## QUESTIONS AND ANSWERS FENCING FOR COYOTE LANDFILL WEST CLOSURE

project Coyote West  
Fence Detail

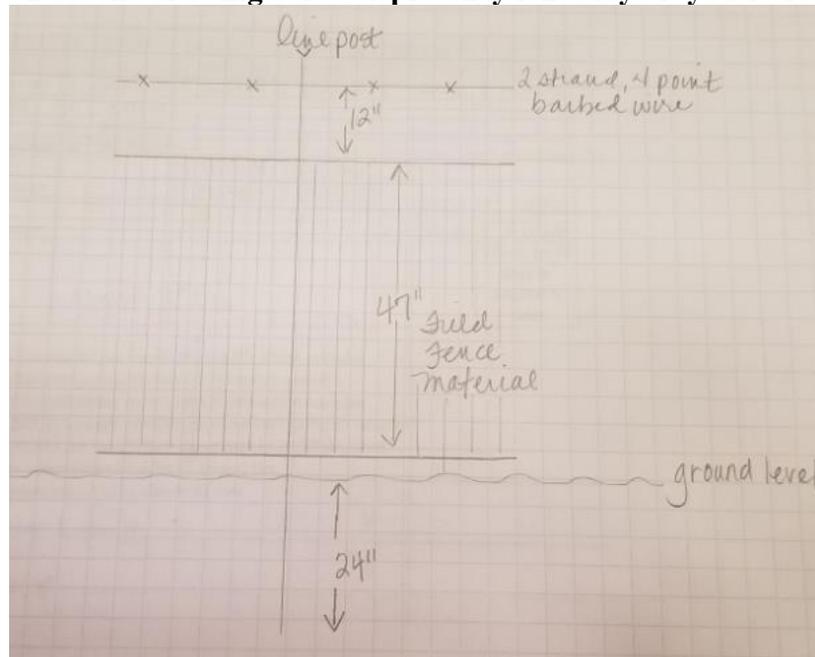
**QUESTION:** Is there any specifications on the 47" field fence?

**QUESTION:** Does the drawing below depict the fence layout you're requesting?

**QUESTION:** What is the size of the holes allowable in the 5' net wire that is to be used on the fence, as shown in the drawing? Is 2"x4" acceptable?

**QUESTION:** Please clarify the requirement of a 6' foot field fence defined in the scope of work vs. the 47" field fence defined in the specifications. Also, will the fence line be cleared wide enough to allow vehicles to drive down it?

**QUESTION:** The narrative calls for a 6ft field fence; assume that is a mistake?

**QUESTION:** Diagram says 1 strand barb wire on the bottom, 1 on top and ft field fence, narrative says 2 stands on top of 47in fence. (Which is correct)?

*ANSWER: Yes, See attached fence detail and the fence specifications below:*

- 47" Field Fence with 2 Strand 4 point, 15 gauge barb wire ; one strand of barb wire to be installed on top and one strand to be installed on the bottom per fence detail.
- 6'6" green T-post with cream/white tip on 10ft. center. Provide wooden post minimum of every 60'.
- 6"x6" H braces , .60 treated pine
- Brace corners, ends, and every 300 ft.
- Twelve foot wide farm gate.

*ANSWER: No, see attached fence detail from County.*

**ANSWER:** *Yes, 2"x4" is acceptable.*

**ANSWER:** *See attached fence detail. The fence line will have an access road on one side of it.*

**ANSWER:** *See attached fence detail.*

**ANSWER:** *See attached fence detail.*
